Amendments to the Drawings

REMARKS

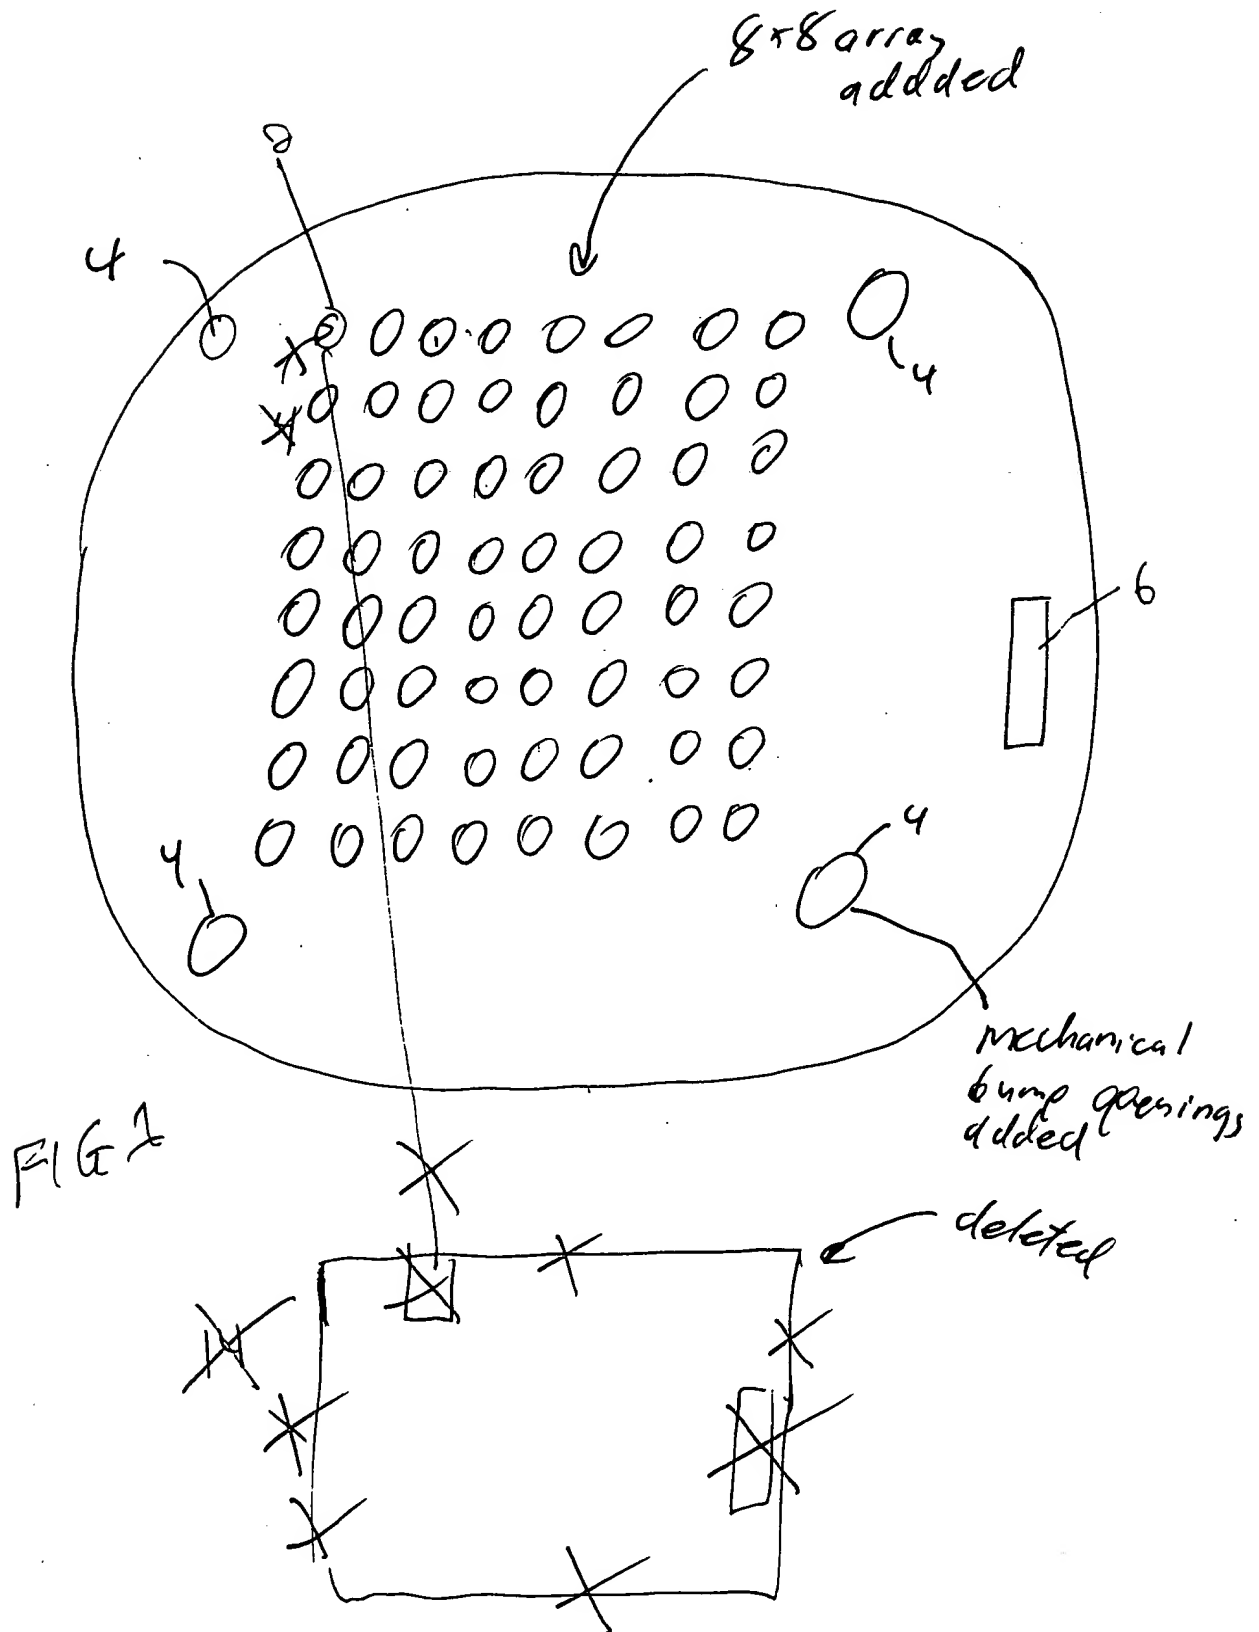
In FIG. 1, the 8X8 array of apertures 2 and the larger mechanical bump openings 4 described, e.g., in paragraph [0024] have been added. Further, detector or chip 14 has been deleted from FIG. 1.

In FIG. 1, the 8X8 array of apertures 2 and the larger mechanical bump openings 4 described, e.g., in paragraph [0024] have been added. No new matter has been added.

FIG 3

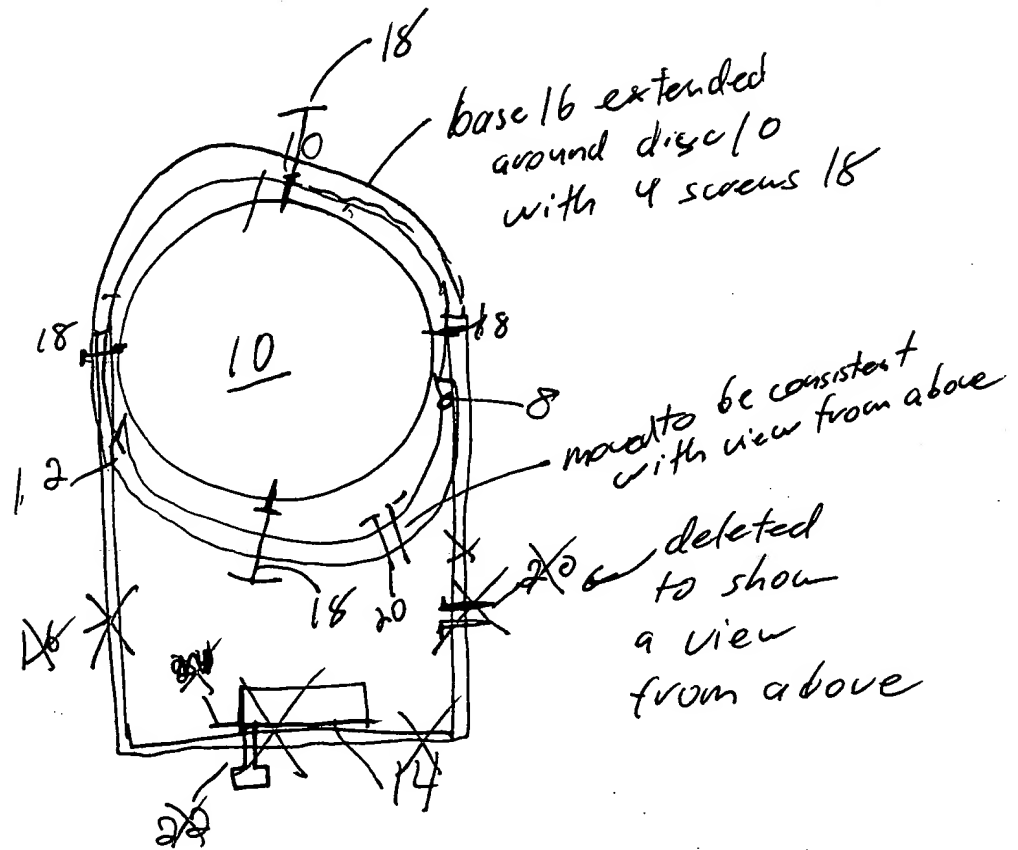
In FIG. 3:

the top portion has been amended to show a view from above the alignment fixture. In particular, base 16 has been shown with all four screws 18 joining disc 10 to base 16 as described, e.g., in paragraph [0026]. Further, the portions of the alignment fixture and detector or chip 14 described as below disc 10 (e.g., in paragraphs [0026] and [0027]) have been deleted; and

the bottom portion has been amended to show a cut away side view of the alignment fixture in a commercial aligner 26 as described, e.g., in paragraph [0029]. Further, thumb wheel 22 and vacuum inlet 20 (as shown in the top portion of FIG. 3) have been added, and lines have been deleted to ensure that aligner 26 is distinguished from base 16.

In FIG. 3, the top portion has been amended to show a view from above the alignment fixture. In particular, base 16 has been shown with all four screws 18 joining disc 10 to base 16 as described, e.g., in paragraph [0026]. No new matter has been added.

Also in FIG. 3, the bottom portion has been amended to show a cut away side view of the alignment fixture in a commercial aligner 26 as described, e.g., in paragraph [0029]. Further, thumb wheel 22 and vacuum inlet 20 (as shown in the top portion of FIG. 3) have been added. No new matter has been added.
